KENWOOD

ASB-1054

Service Bulletin

Subject: AT-50 Mechanical Stability

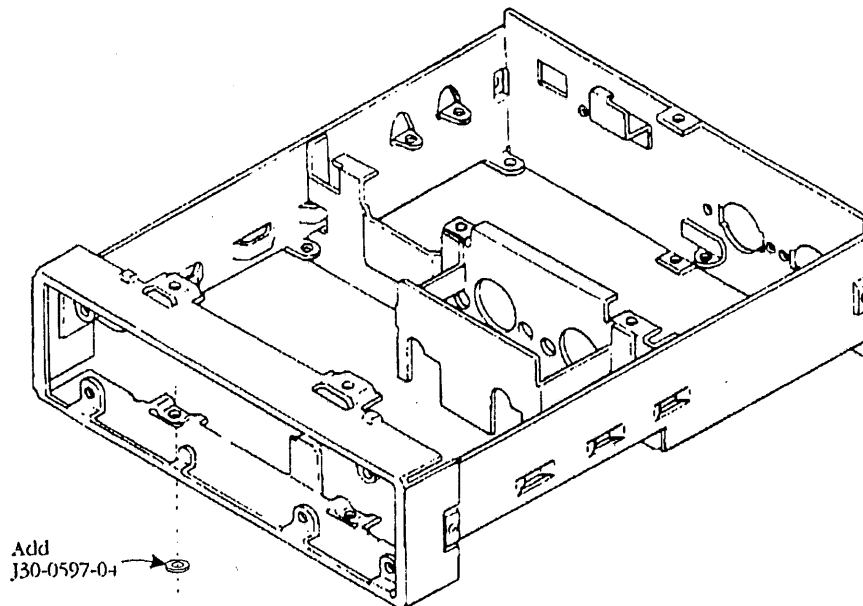
When the unit is placed on a flat surface it appears to be slightly unstable, i.e. rocks back and forth when pressing down on the left front corner of the unit.

Add a flat spacer at the location shown between the chassis and the bottom cover.

| Qty | Description | New Part No. | Circuit Description |
|-----|-------------|--------------|---------------------|
| 1 | Spacer | J30-0597-04 | NA |
